**Evaluation of the 2018 Environmental Impact Assessment (EIA) Report  
For the Vung Ang II Thermal Power Plant Project**

Mark Chernaik, Ph.D.  
Heidi W. Weiskel, Ph.D.  
Staff Scientists  
Environmental Law Alliance Worldwide

April 2020

Figure 3. 19- Simulation of heat transfer scenario (in November) and the probability of over 3 °C temperature difference<sup>18</sup>

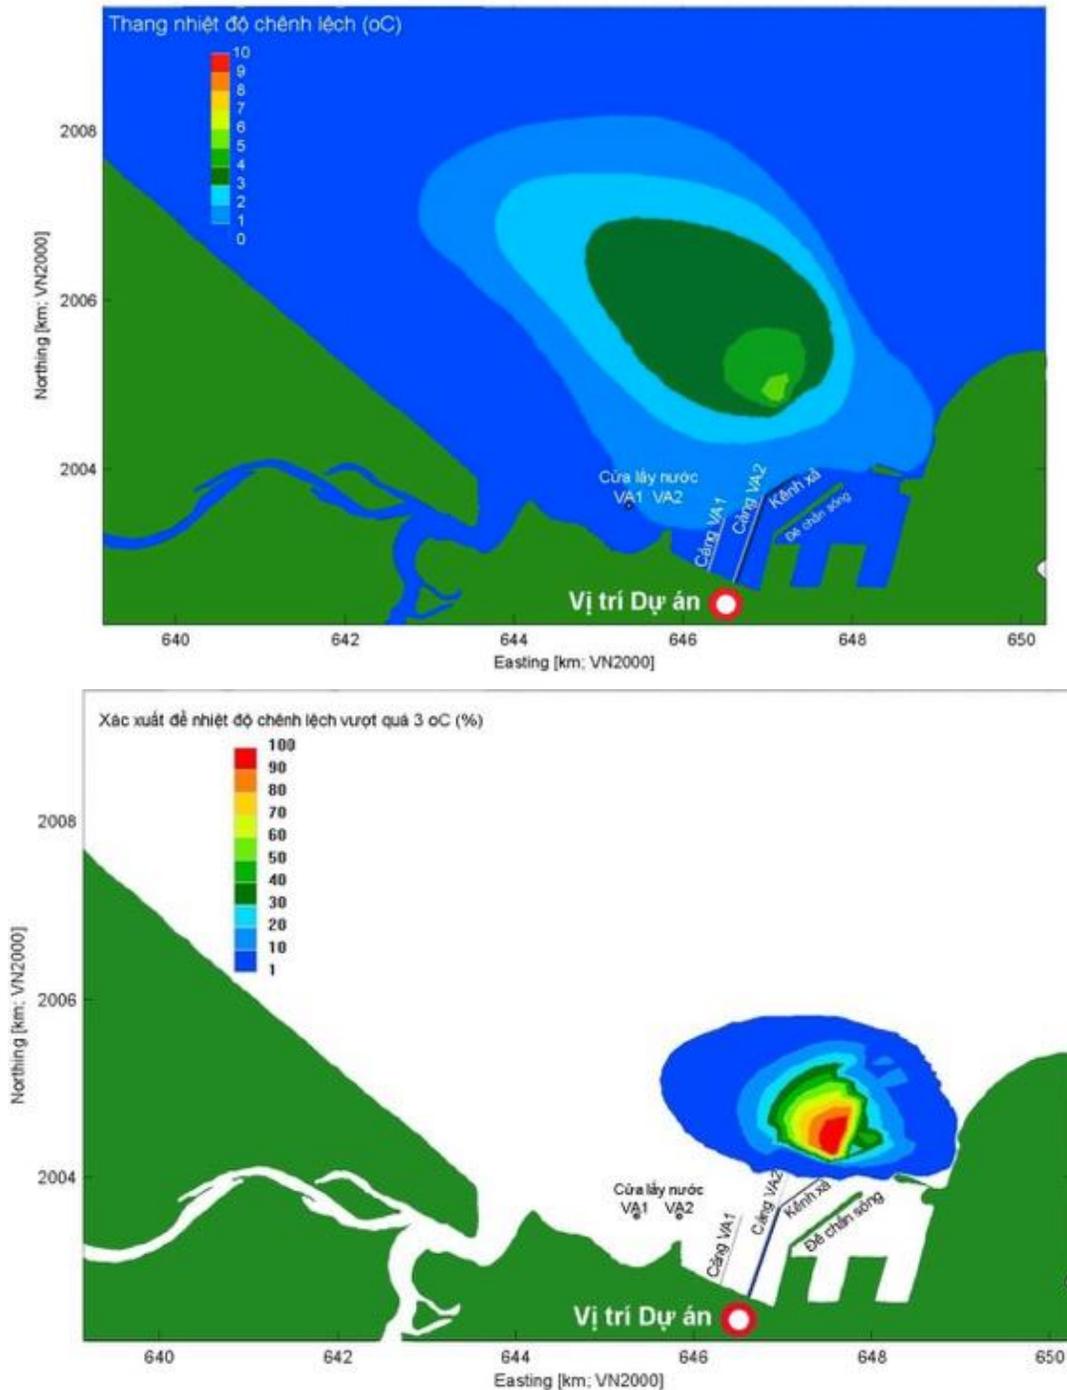
In violation of this standard, the 2018 EIA Report shows that thermal discharges from the proposed Vung Ang II Thermal Power Plant would raise ambient water temperatures by more

than 3°C in the dry season (November), over an elliptical area with a length of more than 500 meters, far exceeding the size of a scientifically established mixing zone. See Figure 3-19 of the 2018 EIA Report below.

However, the IFC Guidelines do not offer a relaxation of the standard even for areas deemed to be for industrial purposes. Moreover, the 2018 EIA Report contains water quality data that contradict the claim that the area that would be impacted by thermal discharges should be characterized as industrial. The 2018 EIA Report states:

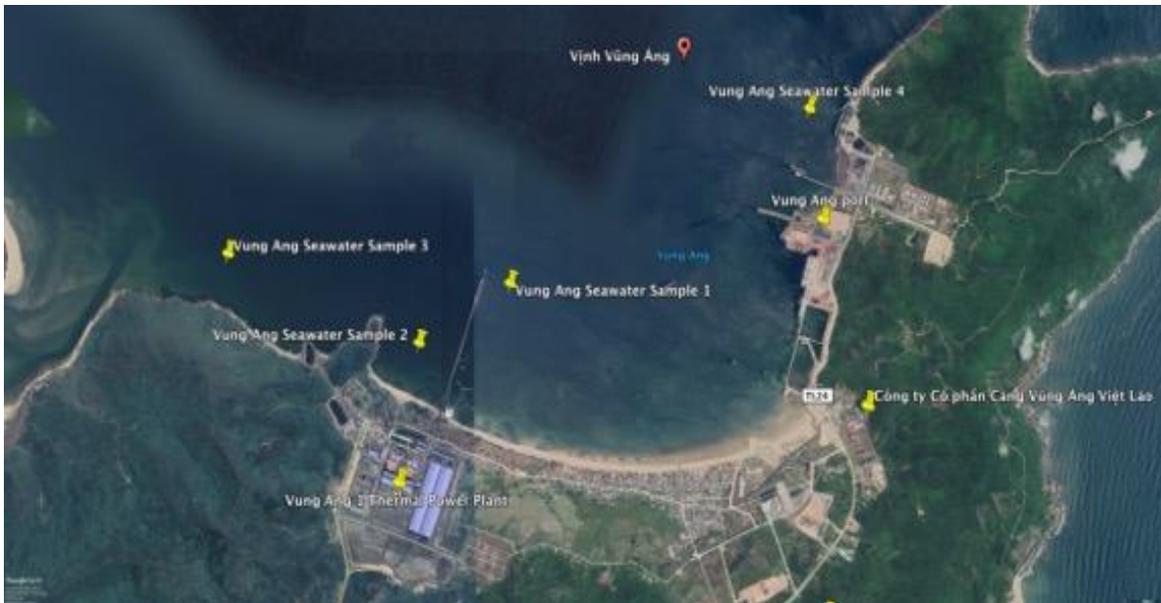
In essence, the water is either polluted by industrial activities or it is not. If the coastal seawater quality data from the project area show no signs of pollution connected to industrial activities—what the proponents claim and the data confirm—then it is especially imperative that IFC limits on thermal discharges be adhered to.
